Title - Sujet Ctr.Pier Repair, Wood Isl. Ferry,PE	
Solicitation No. - N° de l'invitation ED001-162024/A	Amendment No. - N° modif. 004
Client Reference No. - N° de référence du client R.077637.001	Date 2016-01-13
GETS Reference No. - N° de référence de SEAG PW-\$PWC-021-3781	
File No. - N° de dossier PWC-5-38180 (021)	CCC No./N° CCC - FMS No./N° VME
Solicitation Closes - L'invitation prend fin at - à 02:00 PM on - le 2016-01-20	Time Zone Fuseau horaire Atlantic Standard Time AST
F.O.B. - F.A.B. Plant-Usine: <input type="checkbox"/> Destination: <input checked="" type="checkbox"/> Other-Autre: <input type="checkbox"/>	
Address Enquiries to: - Adresser toutes questions à: Donovan, Janine E.	Buyer Id - Id de l'acheteur pwc021
Telephone No. - N° de téléphone (506) 636-5347 ()	FAX No. - N° de FAX (506) 636-4376
Destination - of Goods, Services, and Construction: Destination - des biens, services et construction:

Cette modification à l'invitation numéro quatre (4) est soumise pour inclure l'addenda numéro 4 suivant.

Addenda 4.

Question 3: Ref: Dwg S4 of 4- Detail 6, Section A and B, Detail 2

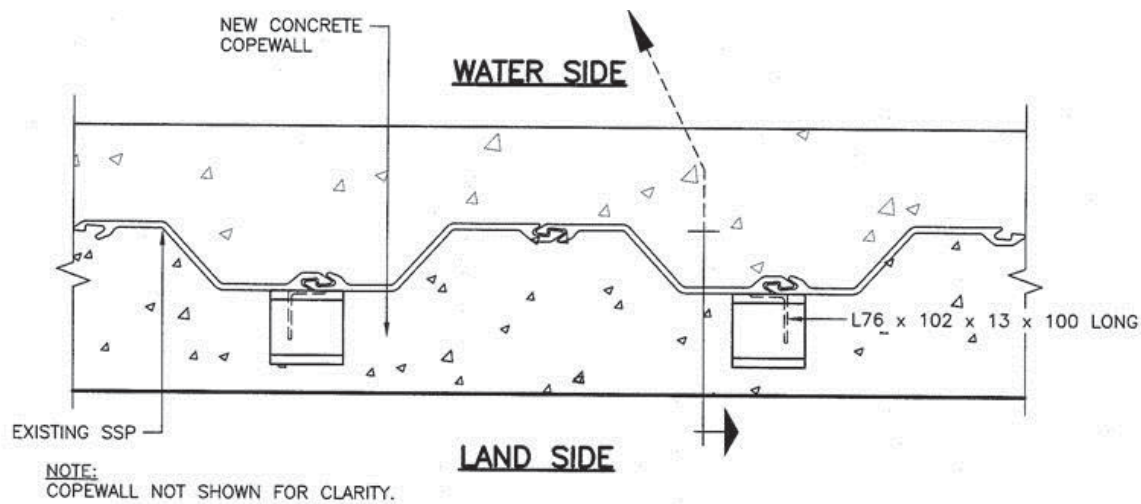
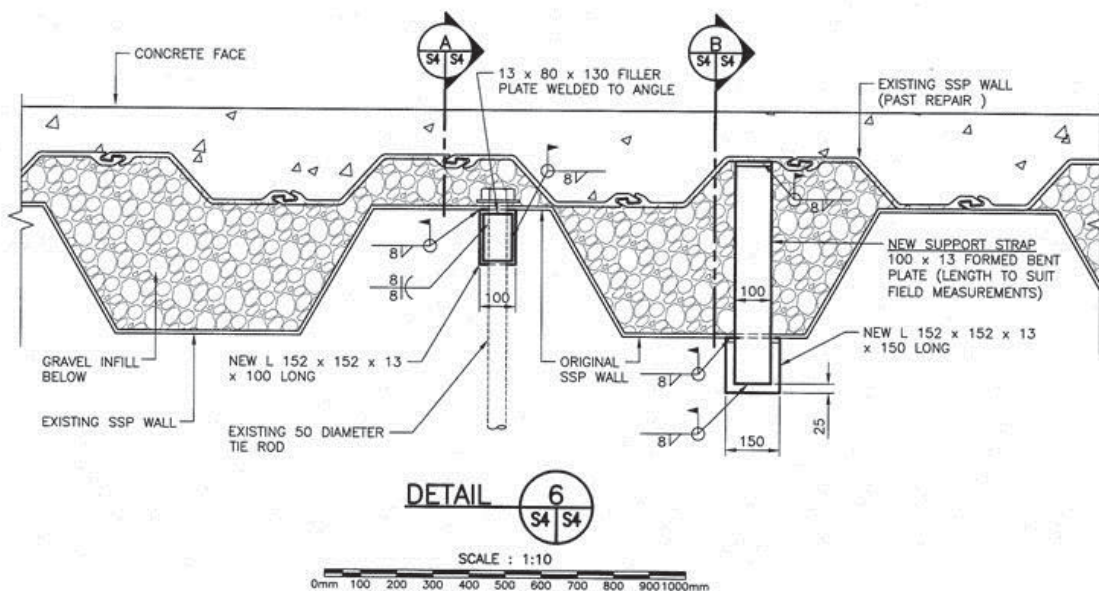
Please confirm the spacing of the lugs shown in Detail 2. Also please confirm if the support strap shown in detail 6 shall only be installed adjacent to the Existing 50mm tie rods (1905mm spacing), or if there is a different regular spacing.

Answer 3: See responses below, referencing the above shown details:

1. Detail 2/S4, Add the following note. "INSTALL LUGS ON EACH SSP IN-PAN (APPROX. SPACING 950MM+/-)"
2. Detail 6/S4, Add the following note. "ONE NEW SUPPORT STRAP IS REQUIRED PER TIEROD"
